Date	8 December 2025
To	Waitaha Hydro Expert Panel FTAA-2505-1069
From	James Bentley
Project advice provided for	<i>Waitaha Hydro Scheme</i>
Documents referred to	<i>Waitaha Hydro Scheme Substantive Application Appendix 27 Landscape and Natural Character</i>
Signature

Landscape and natural character questions 5 – 9.

Figure 1: Snip of the graphic model used for Power Station Simulations

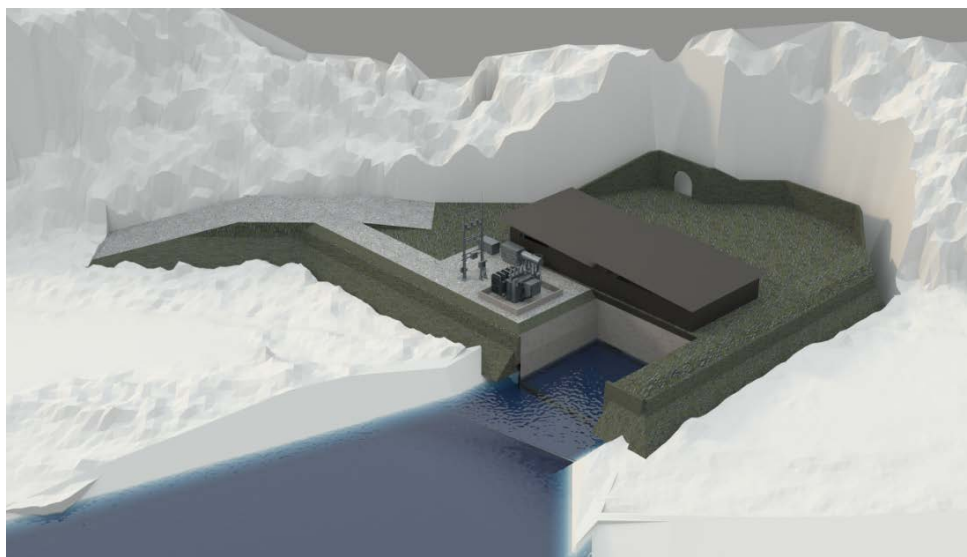
Question 7: Update/provide visual simulation(s) of the power station looking back to the access road and including the transmission line.

9. It is not entirely clear where the panel are considering this updated or new visual simulation be from, however, I trust that the labelling of component parts shown in simulations PH1, PH2, PH3 and PH4 supplied within Appendix A of this response goes some way to answering this question.
10. In terms of an explanation of the graphic model used for the Power Station component, Figure 1 below represents the extent of what was used to model the Power Station in the visualisations. This confirms that only part of the Power Station access road was modelled and transmission lines are not included.
